TECHNICAL BULLETIN
Bell Helicopter **TEXTRON**

No. 230-99-26

SUBJECT: TAIL ROTOR GEARBOX P/N 222-042-001-007,
-101 AND -103 CONFIGURATION CHANGE
AND UPGRADE

TAIL ROTOR GEARBOX

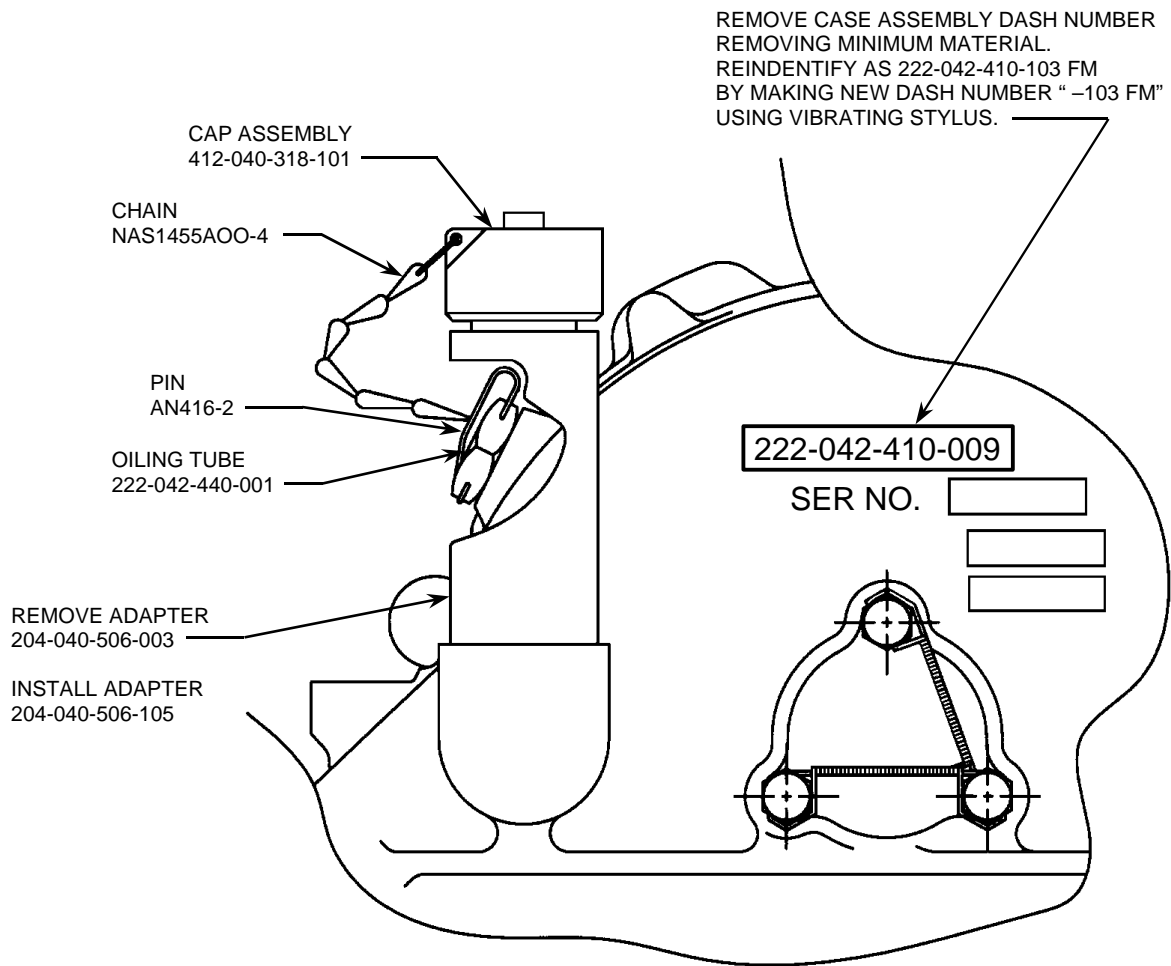
11. Using P/N AN416-2 pin, secure chain on oil filler cap assembly P/N 412-040-318-101 to one of the holes in the hex head of P/N 222-042-440-001 oiling tube. Refer to Figure 1.

- a. Remove case assembly -009 dash number by removing minimum material. Reidentify as 222-042-410-103 FM by making new dash number "-103 FM" using vibrating stylus. The serial number of a field modified part will not be altered or changed. Refer to Figure 1.
- b. Chemical film treat reworked area as per BHT-ALL-SPM, Table C-1, Item B-2. Touch-up using primer (C-204 or C-246) and topcoat using paint (C-245).
- c. Reidentify case assembly as 222-042-410-103 FM in the historical records.
